Response to Comments on Vapor Intrusion Work Plan Review With Comments

Date:	September 4, 2024	Jacobs Engineering Group Inc.
Project name:	Tyco Fire Products LP, One Stanton Street, Marinette, Wisconsin	1610 N 2nd Street
Project no:	D3868400	Suite 201
Attention:	Andrew Kleinberg	Milwaukee, WI 53212
Company:	U.S. Environmental Protection Agency	United States
Prepared by:	Jacobs	T +1.414.272.2426
Document no:	D3838400.314	F +1.414.272.4408
Copies to:	Sarah Krueger, WDNR Angela Carey, WDNR Ryan Suennen, Tyco Fire Products Denice Nelson, Johnson Controls Heather Ziegelbauer, Jacobs Dave Finney, Jacobs	www.jacobs.com

Attachment 1. Vapor Intrusion Conceptual Site Model
Tyco Fire Products LP
Marinette, WI

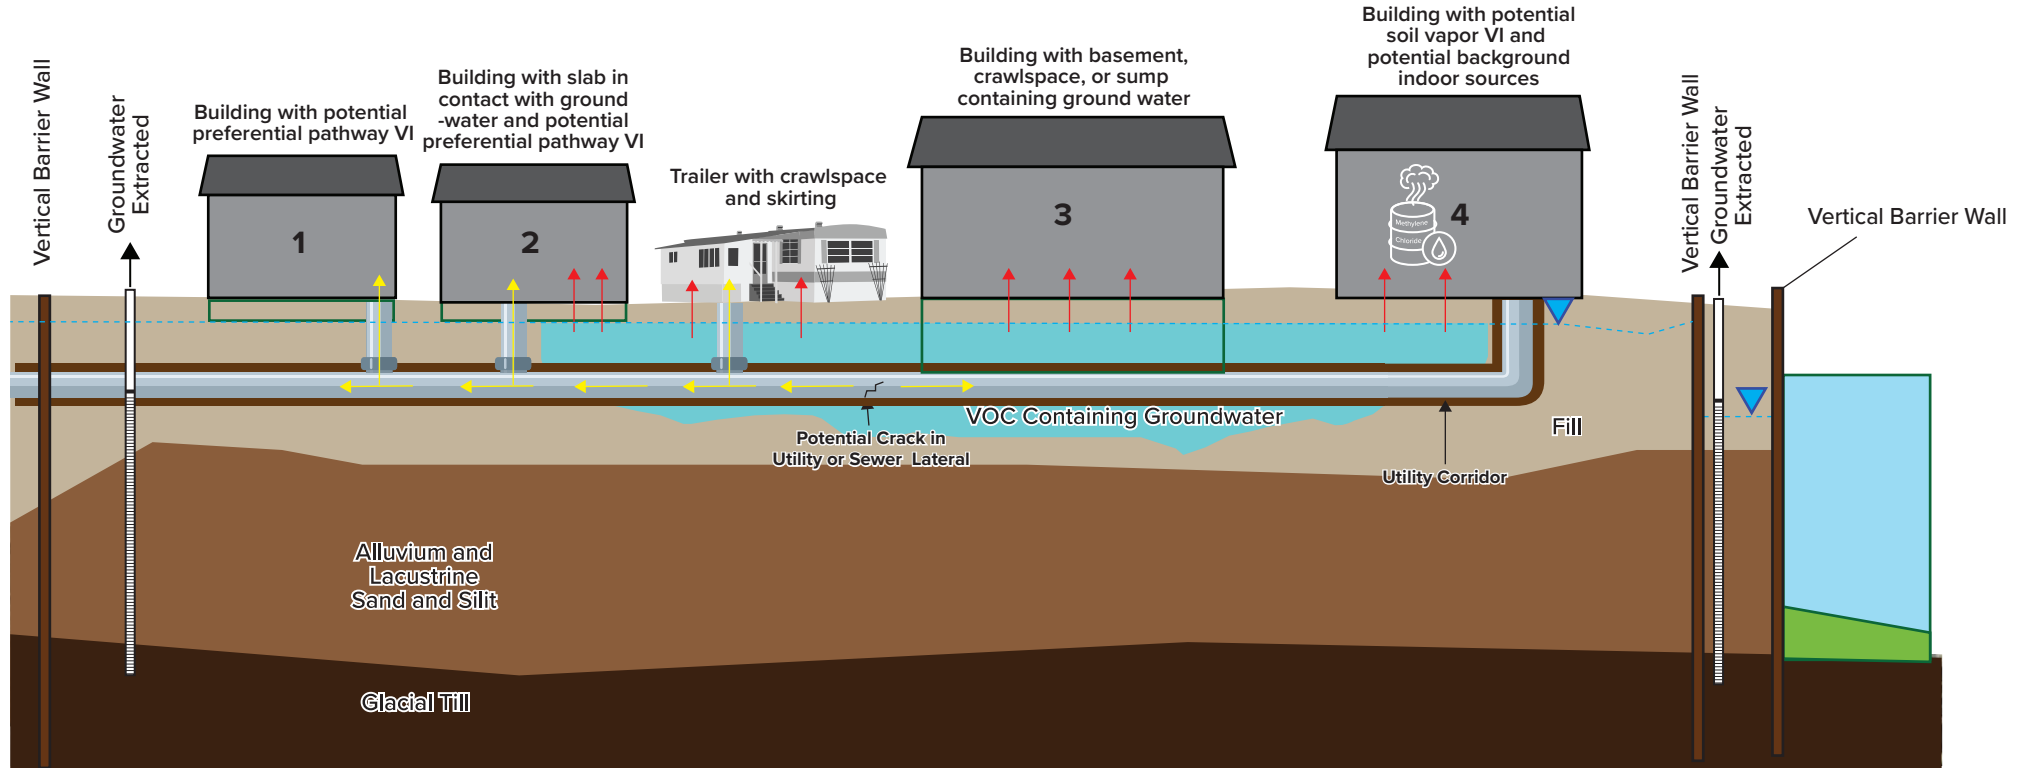
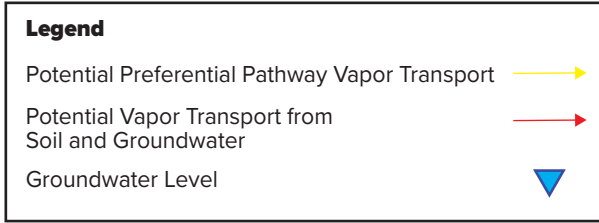
Develop a separate Conceptual Site Model (CSM) as it relates to volatile organic compounds (VOCs) and vapor intrusion (VI). The current CSM is developed for groundwater, soil, and sediment contamination that resulted from arsenic-salt waste piles and does not consider all migration pathways that are relevant to VOCs and VI. The CSM must include an assessment of preferential pathways, e.g. utilities, to meet the requirements of Wis. Admin Code NR716.11(5)(a).

- a. *An evaluation should be performed to determine if the current and/or historic underground utilities may be acting as a preferential pathway for contaminant migration and should*

include information on how utilities were abandoned. Guidance document RR-649 provides information on investigating human-made preferential pathways.

A draft CSM specific to VI that also includes an assessment of preferential pathways is provided as Attachment 1. An updated CSM will be provided as part of the updated VI assessment and work plan. This CSM will be further updated and refined as more information becomes available, including the findings from future VI investigations.

FIGURE 2
PROPOSED VAPOR INTRUSION INVESTIGATION LOCATIONS

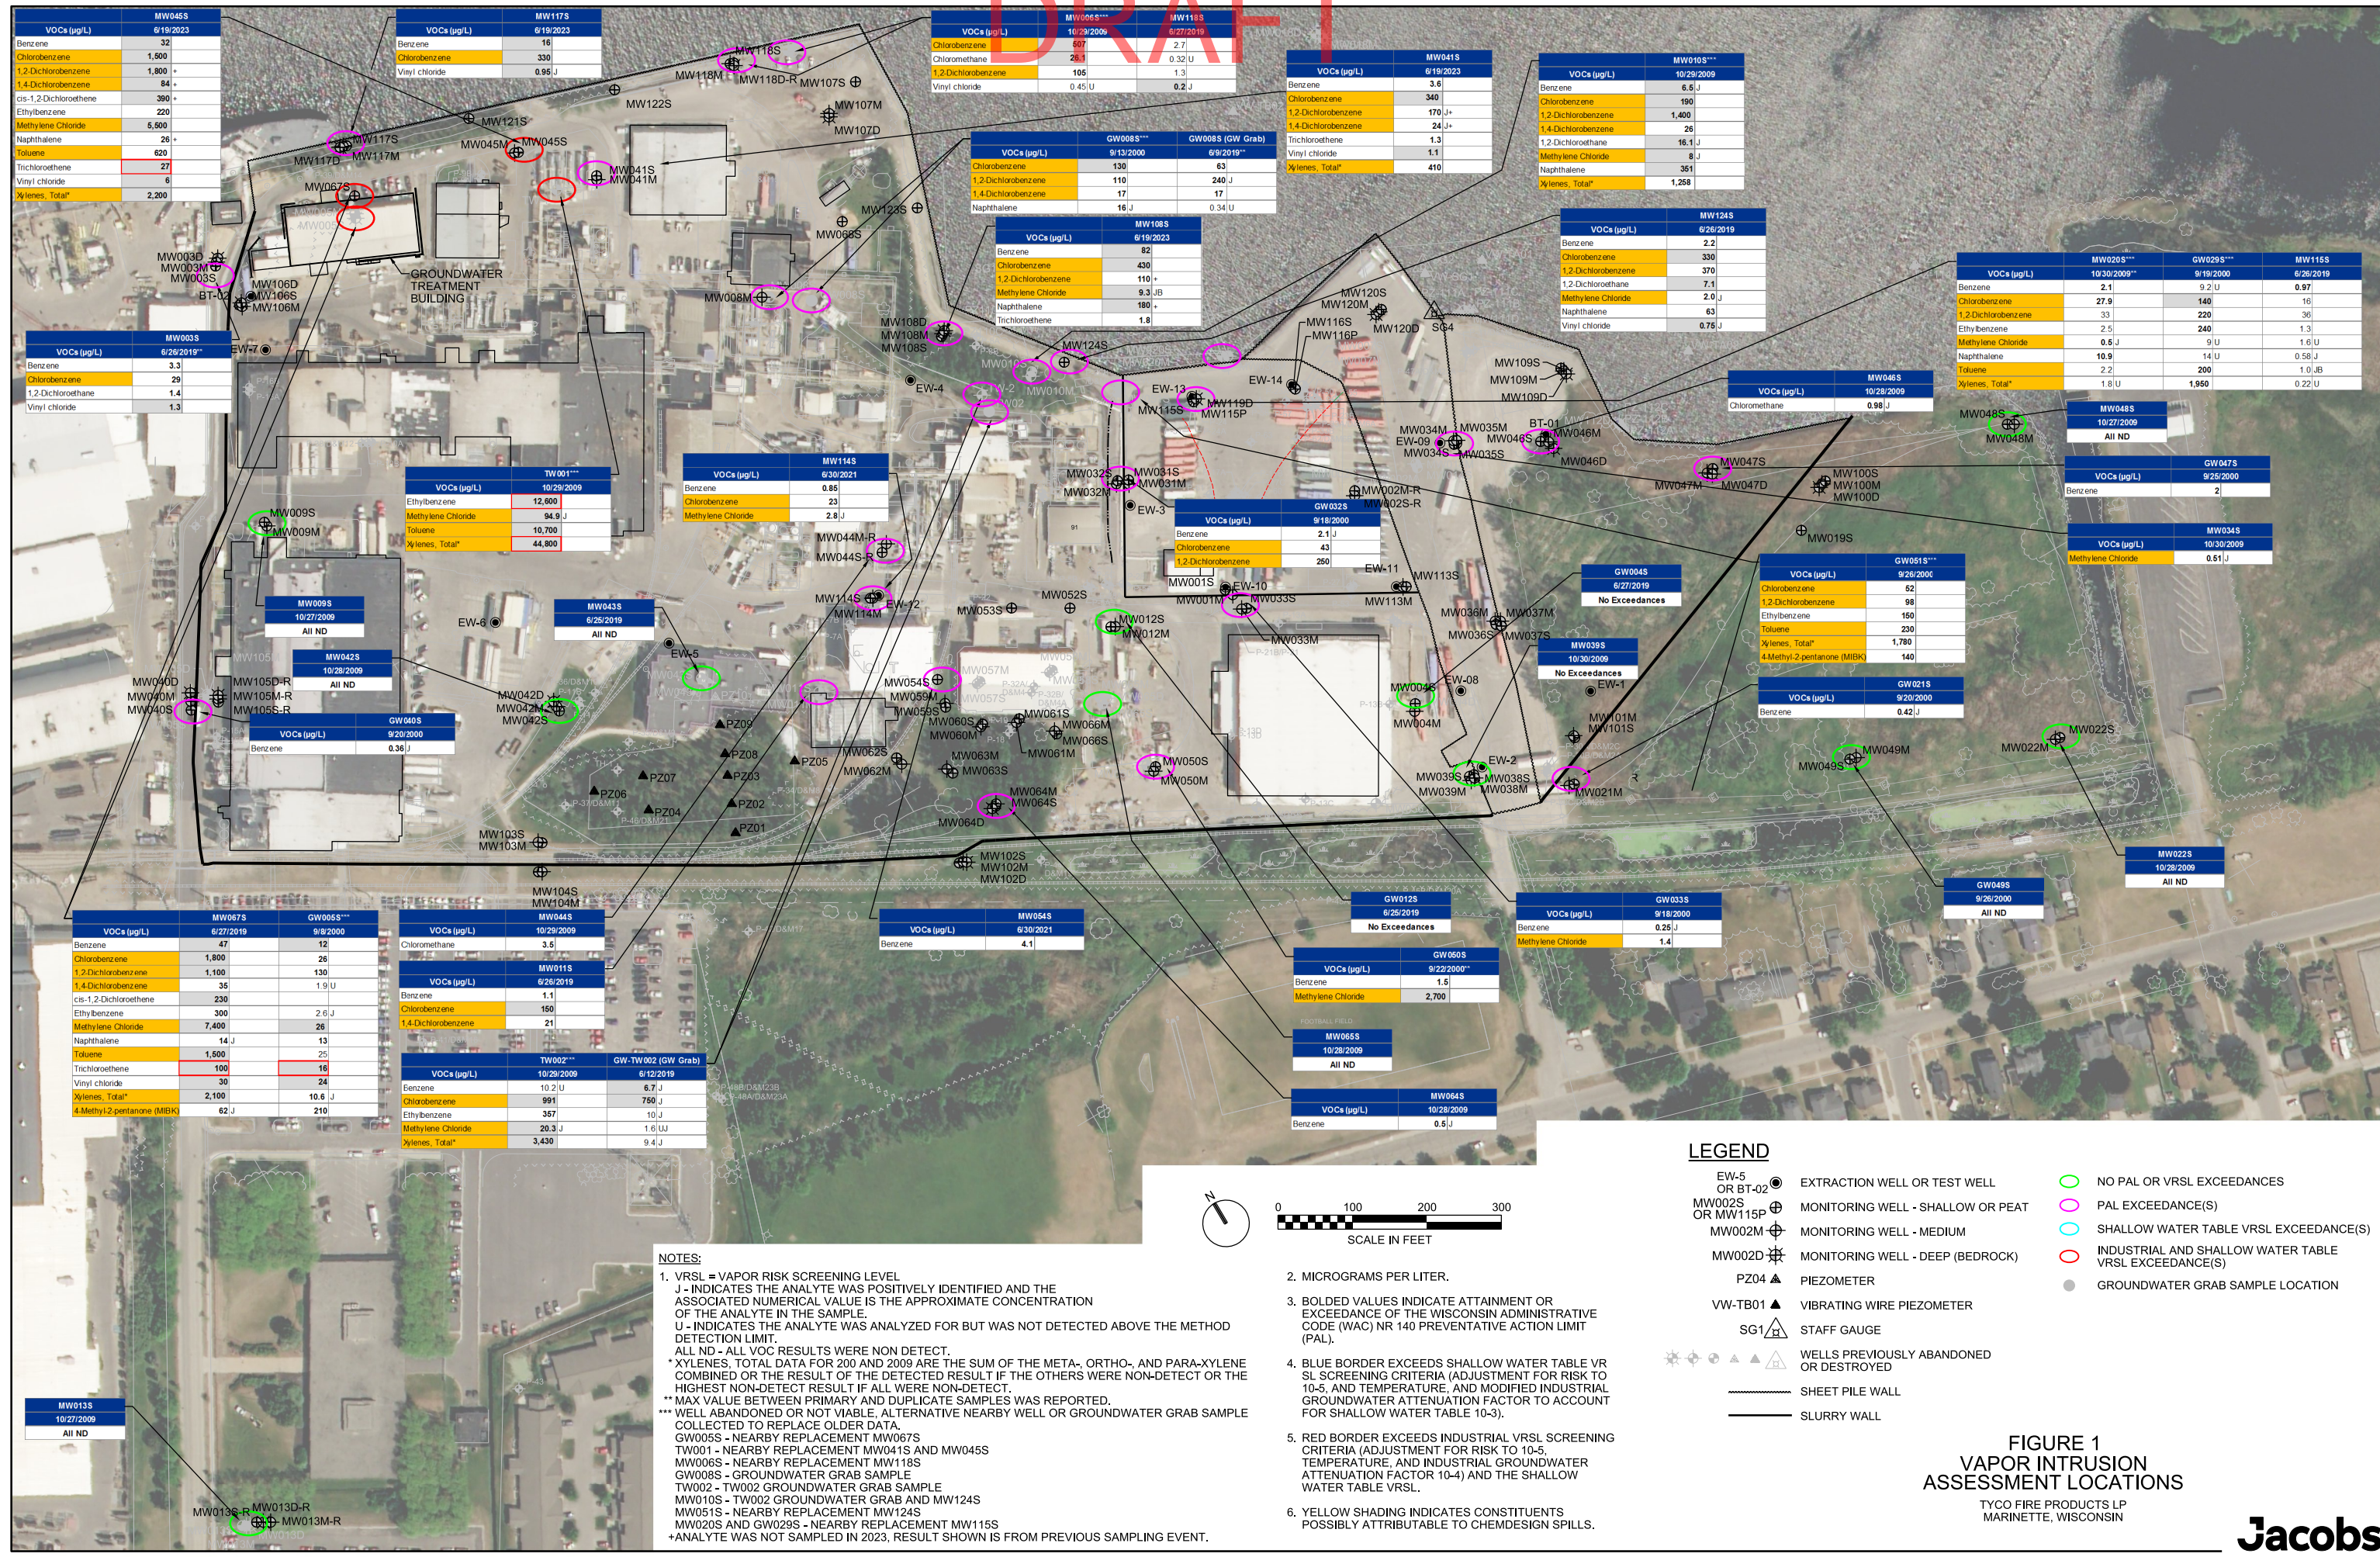
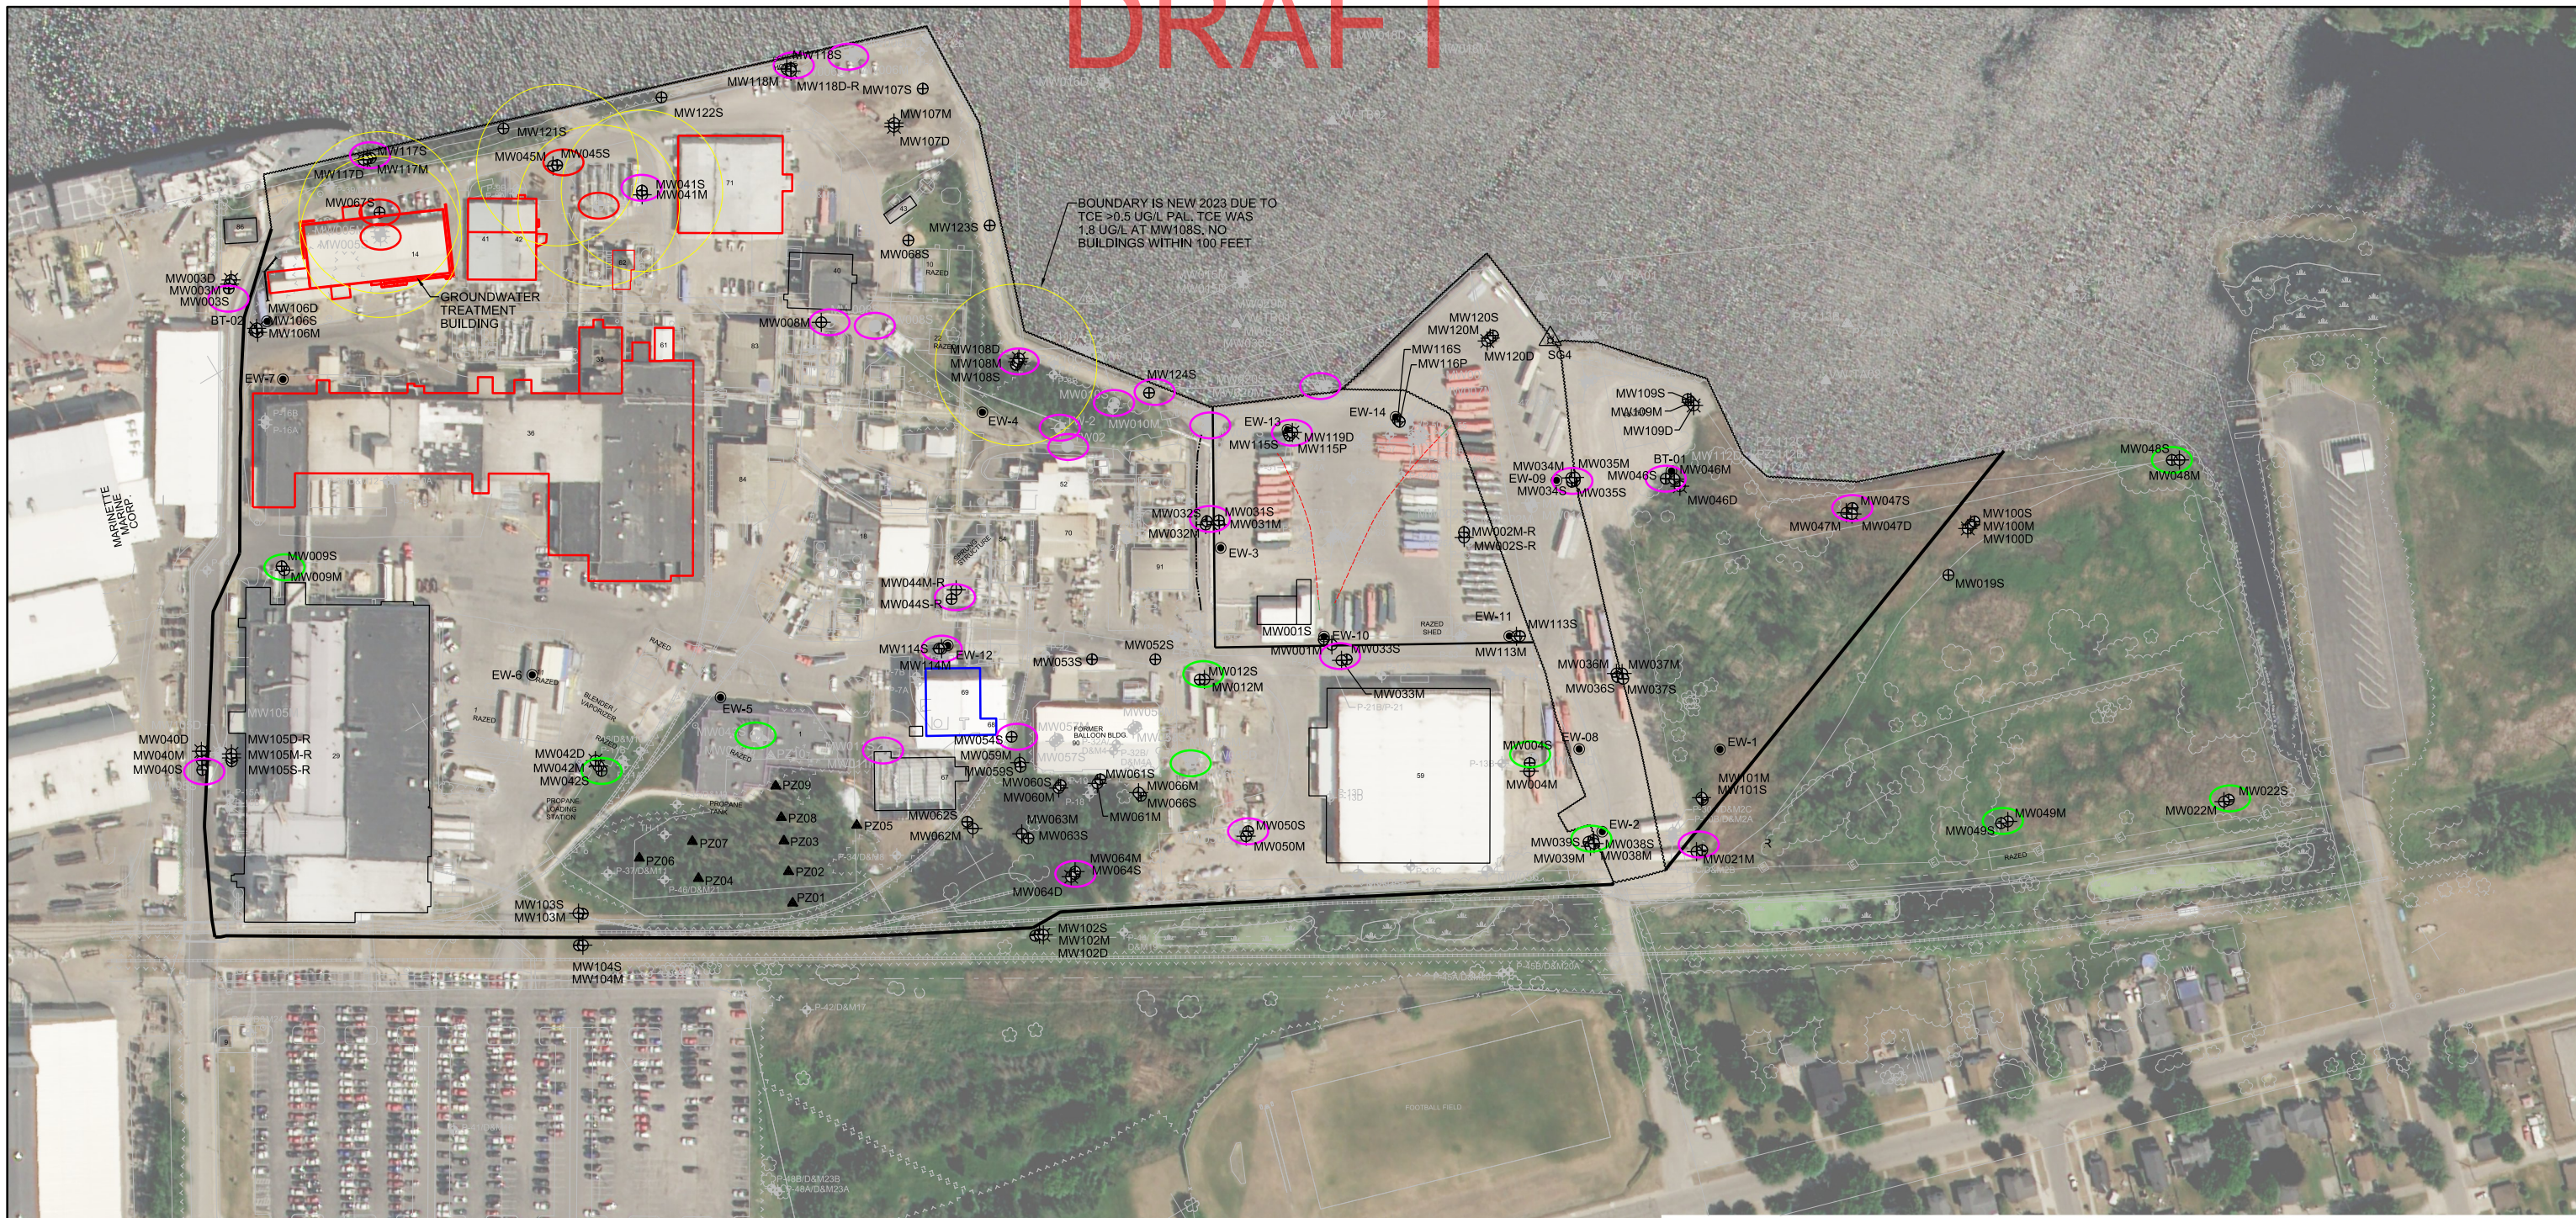
- a. The screening process did not include preferential pathways. An evaluation of preferential pathways must be included in the VI assessment; indoor air sampling may not be used as screening criteria in lieu of this assessment as indicated on page 4. The potential for in-pipe vapor migration should be assessed and include an evaluation of sanitary sewer(s) connected to buildings that utilized VOCs. Guidance document RR-649 provides information on performing an in-pipe sanitary investigation.*

- b. The use of VOCs in a building does not preclude it from a vapor assessment. Any buildings that screen in based on other factors, such as proximity to residual VOC contamination in soil and/or groundwater, must be evaluated. WDNR does not allow preemptive mitigation of vapors in lieu of sampling, and the presence of a vapor barrier does not eliminate the need for a vapor evaluation. Vapor barrier information should be submitted to EPA and WDNR and should include the barrier's specifications as they pertain to mitigation of chemical VI and resistance to degradation by the contaminants of concern for the site, along with barrier installation documentation.*

The screening process is being updated to include buildings (regardless of whether there is current VOC usage) within 100 feet of a shallow groundwater monitoring well that has VOC concentrations greater than the VRSLs, or in an area of the site where VRSLs could potentially be exceeded, but no groundwater data are available (Attachment 4 with draft Figures 1 and 2).

The PAL for TCE was compared against the shallow groundwater dataset obtained through 2023 (Attachment 6) (note this comparison was also done in the 2021 Work Plan). No buildings were present within 100 feet of a TCE PAL exceedance (Attachment 4) that were not already included from the evaluation of shallow groundwater concentrations exceeding the VRSLs.
